## REQUEST FOR COUNCIL ACTION

AGENDA SECTION: PUBLIC HEARINGS- Continued Item	ORIGINATING DEPT: PLANNING	ITEM NO. <b>E-3</b>
ITEM DESCRIPTION: General Development Plan #206 to be known as Morris Meadows by Morris Memorial LLC and Allen Koenig. The applicant is proposing to develop the property with commercial and industrial uses. The plan also identifies future roadway patterns on the property to the west and storm water detention facilities. The property is located along the west side of TH 63, east of East River Road NE and north of 41 <sup>st</sup> Street NE.		PREPARED BY: Brent Svenby, Planner
<p>NOTE: <i>See CPEC minutes from previous LUPA hearing</i> September 30, 2003</p> <p>NOTE: A revised GDP was submitted on September 19<sup>th</sup>. Staff would recommend additional conditions be placed on the GDP based on the revised GDP. The additional conditions are shown as underlined on the RCA. Conditions to be deleted are stricken.</p> <p><u>City Planning and Zoning Commission Recommendation:</u></p> <p>On May 14, 2003 the City Planning and Zoning Commission reviewed this General Development Plan. The Commission also reviewed a Land Use Plan Amendment and zone change for the prop

MORRIS MEADOWS  
GENERAL DEVELOPMENT PLAN  
PART OF THE SW 1/4  
SECTION 13, T 107 N, R 14 W  
OLMSTED COUNTY, MINNESOTA

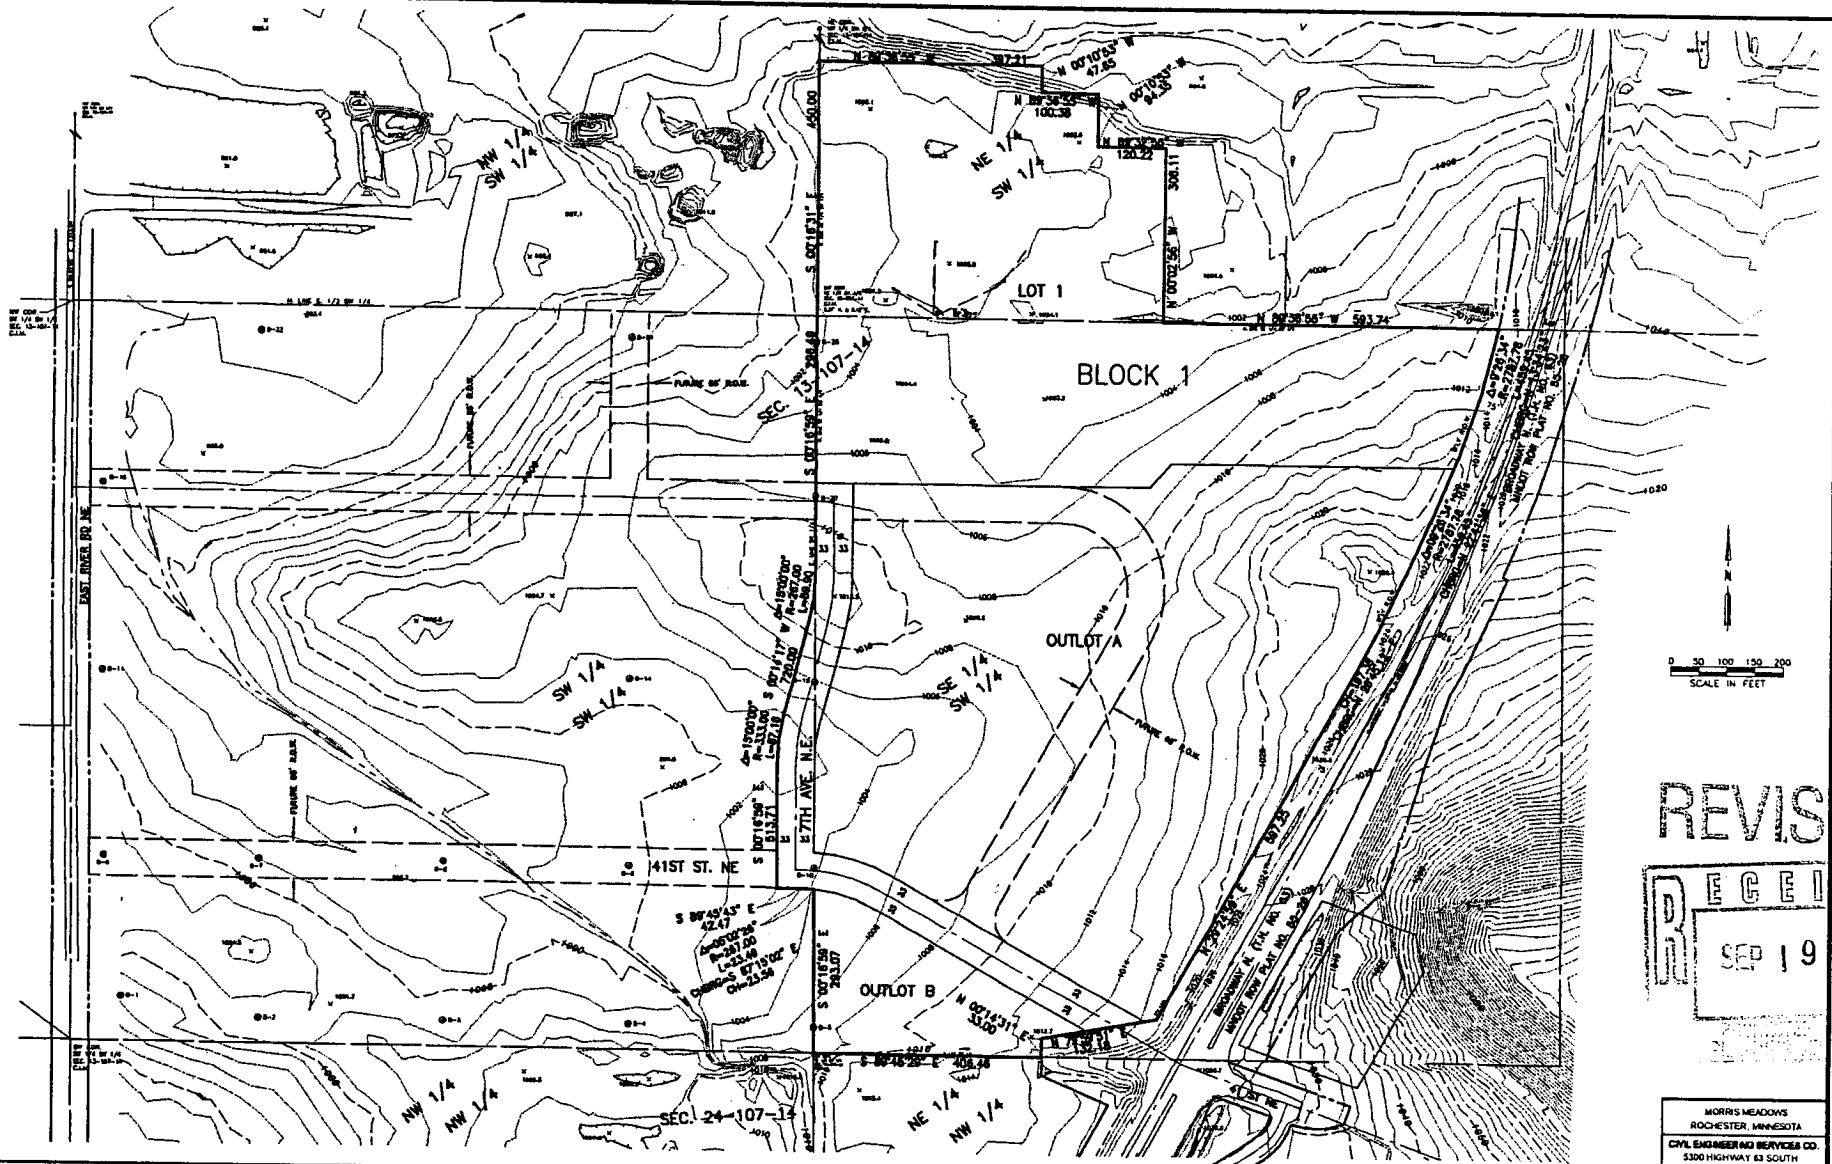
3. It is understood that the GDP includes only the easterly parcel, and does not extend to East River Rd. Since conceptual connections are being shown, the future ROW of East River Rd should be indicated as 60 feet.

6. Controlled Access will be required along the entire frontage of T.H. 63 with the exception of any approved public road access point(s). Additional controlled access will be required along ~~the entire south line of proposed Lot 8, Block 1, and along the 41<sup>st</sup> St frontage of that part of Lot 1, block 2, from T.H. 63 to the ROW of the future street serving Block 1.~~ **both sides of the proposed 41<sup>st</sup> St NE extension, from T.H. 63 to the future 66 ft ROW indicated on the GDP. In addition, access control shall be dedicated along the entire easterly line of proposed Outlot 'B'.**

7. Off site drainage easements may be required to accommodate the proposed relocated drainage way.
8. ~~The proposed extension of 41<sup>st</sup> St on the west side of T.H. 63 shall be perpendicular to T.H. 63 and align directly across from 41<sup>st</sup> St on the east side of T.H. 63.~~

9. **A 50 foot wide access easement shall be dedicated from 41<sup>st</sup> St NE to the RPU property to the south.**
10. **Execution of a City-Owner Contract is required prior to the construction of public infrastructure to serve this Property.**

The access shown aligns with 41<sup>st</sup> Street NE on the east side, but is within an area currently designated as access control. In our discussions with the City of Rochester regarding the location of the access for Morris Meadows, we have indicated that an access swap, removing the current access in order to provide an alignment with 41<sup>st</sup> Street NE on the east side of US 63, is acceptable provided the adjacent property to the south of Morris Meadows will still have reasonable access to US 63. We understand that Outlot B has been sold to the adjacent property owner for the purpose of allowing this property alternative access.

- ~~5. The GDP shall be revised to show the extension of 41<sup>st</sup> Street NE to be perpendicular to TH 63 and align directly across from 41<sup>st</sup> Street NE on the east side of TH 63.~~

7. On the 41<sup>st</sup> St eastbound approach to TH 63, adequate roadway width should be provided to allow for two eastbound lanes, one to exclusively handle the east to south right turn movement which is expected to be the heavy traffic movement at the intersection, and the second to handle the thru and left turn movements. Lane widths should be adequate to handle large truck traffic.

8. The applicant shall obtain an access permit from MnDOT for access to TH 63 as stated in the letter dated September 24, 2003 from MnDOT.
9. The applicant shall dedicate a 50 foot wide access easement from the proposed 41<sup>st</sup> Street NE to the RPU property to the south.

Figure 12  
Access Concern  
Area # 3

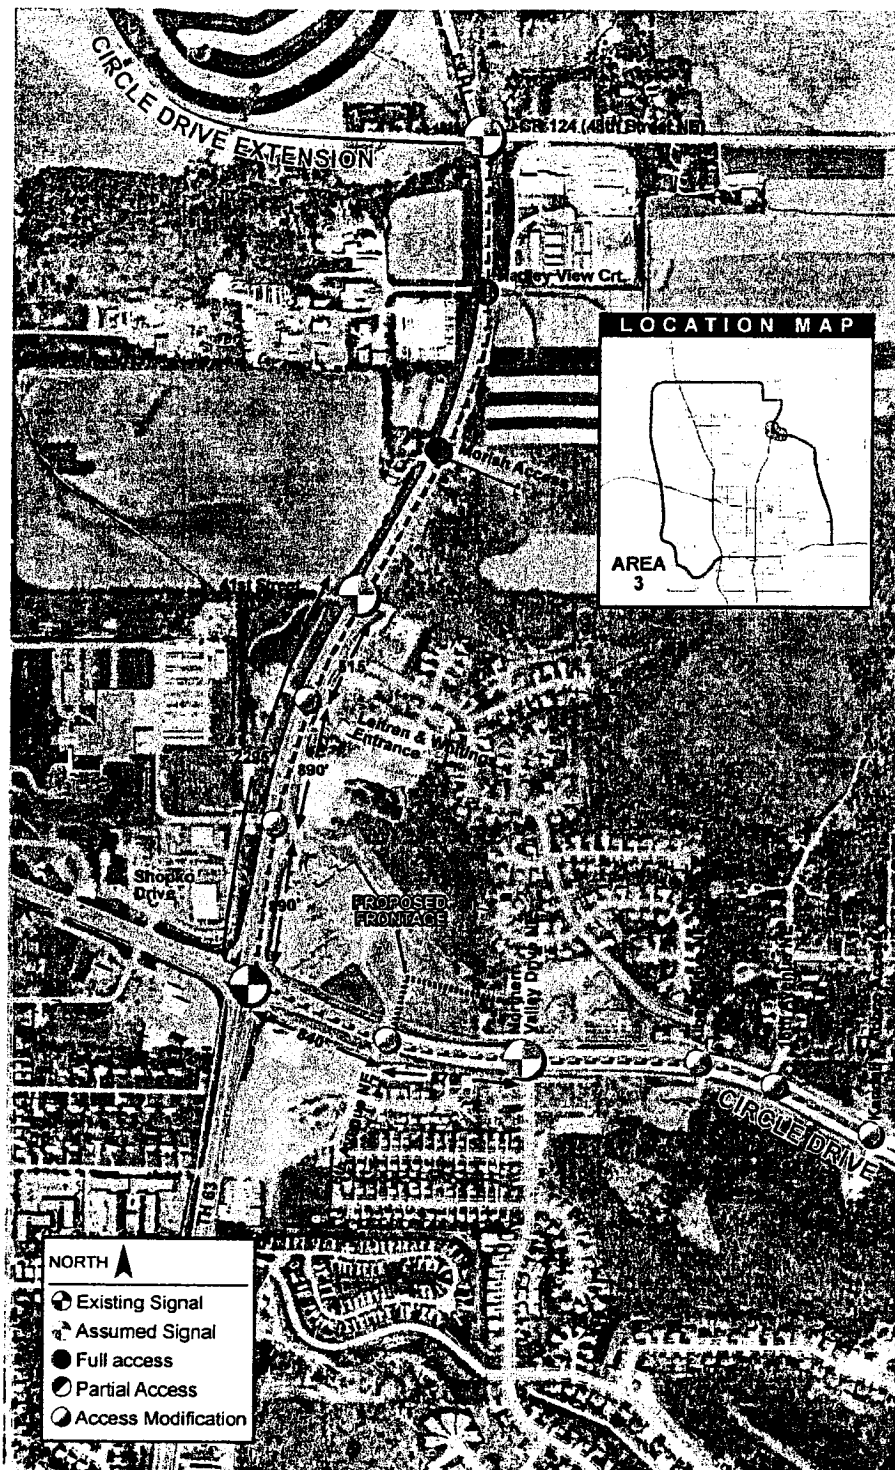
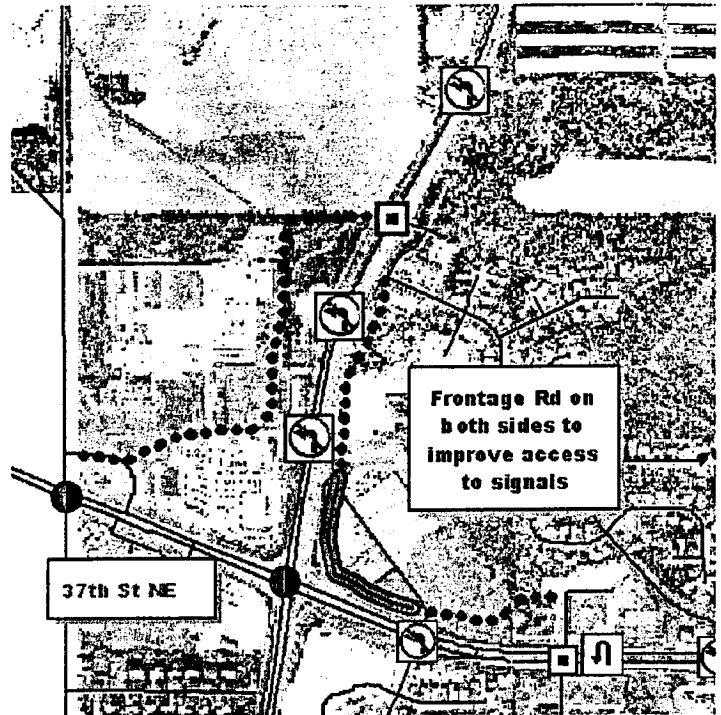
- The proposed intersection of 41<sup>st</sup> St and TH 63 was evaluated as part of ROCOG's Circle Drive Traffic Management Study which was conducted in 2001-2002. The graphic on page 2 illustrates the recommended access and traffic control measures anticipated for implementation along TH 63 north of 37<sup>th</sup> St. The 41<sup>st</sup> St intersection is targeted as the location of a future traffic signal based on its location and the spacing it provides between 37<sup>th</sup> St and 48<sup>th</sup> St.

- Development of the property will contribute to the need to eventually install a traffic signal at the intersection of TH 63 and 41<sup>st</sup> St NE when warrants are met. The development should be responsible for a proportionate share of the cost of this improvement

- On the 41<sup>st</sup> St eastbound approach to TH 63, adequate roadway width should be provided to allow for two eastbound lanes, one to exclusively handle the east to south right turn movement which is expected to be the heavy traffic movement at the intersection, and the second to handle the thru and left turn movements. Lane widths should be adequate to handle large truck traffic.

- Provisions for access control should be provided on the final plat along the following lot frontages:
  - The frontage along TH 63 except for the 41<sup>st</sup> St intersection;
